PROFILE ALIGNMENT AND GRADE OF P.C. 7599
SANITARY SEWERS PAGE 1
TO BE CONSTRUCTED IN
WILEY CANYON ROAD
PRIVATE CONTRACT NO. 7599

W.S. 62
3 SHEETS; 6 PAGES
SCALE: VERT. 1"=8' HORIZ. 1"=40' MAY , 1966
38634

P. C. 7599 PAGE 2

SPECIAL ENCASEMENT DETAIL
Terminate longitudinal Bars 3" from each end of encasement

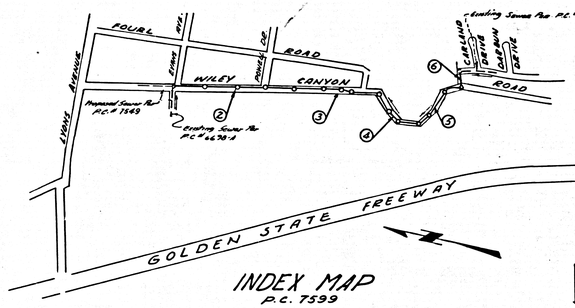
REVISIONS Pg. 1&2
Revised location of J.C. @ Sta. 14+92.65 To 14+18.15. Revised Alignment from Sta. 14+52.75 To 20+19.62. Deleted Special Encasement Detail 1
By Ralph Schafer RCE 13906 date 7/10/66
